REMARKS

REPLACEMENT SHEET 2/6

Fig.2a

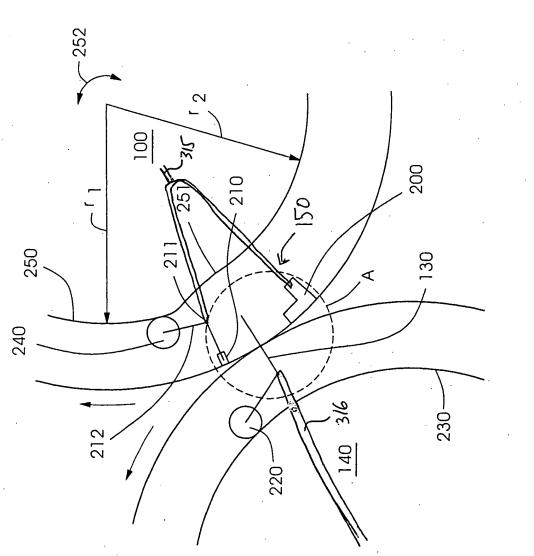
Fig. 2a has now been amended to show with more clarity how each spider, as shown also in Fig. 3, support the grippers 150 and tuckers 130.

With respect to claim 1, then, the specification describes a collect cylinder 100 having a gripper 132 and a tucker 130, and a jaw cylinder 100 with jaw 150 interacting with tucker 130, as also now shown in Fig. 2a. Jaw 150 has a stationary jaw part 200 and a movable jaw part 211

Fig.3

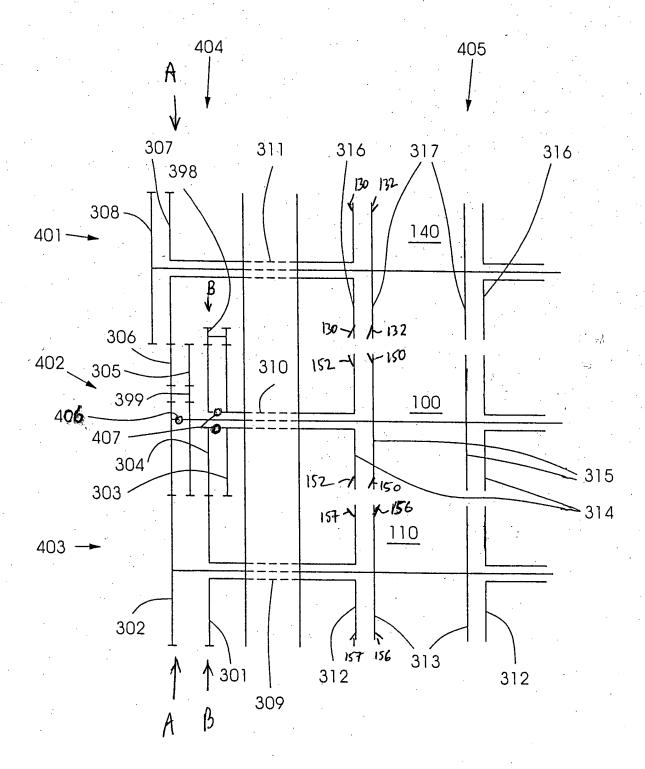
Fig. 3 has been amended to show the position of the gearing shown in Figs. 5 and 6.

F16.5

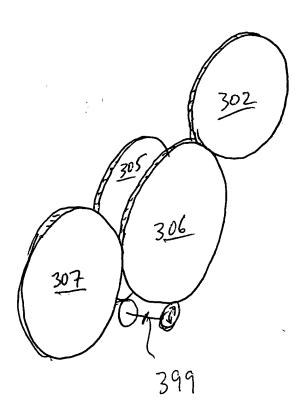
Figs. 5 and 6 show perspective views of the regions A-A and B-B, respectively.

With these views the adjusting via adjusting center 399 is clear as described in the specification: gear 307, which drives spider 316 and tuckers 130, is geared via gear 306, adjusting center 399, gear 305, and spider 315 to jaws 150, which have the fixed jaw part 200 of Fig. 2A. Adjusting center 399, for example using a helical gear, alters the phase between gears 305/306, so that they rotate relative to one another. See [0037] to [0039] of the specification.
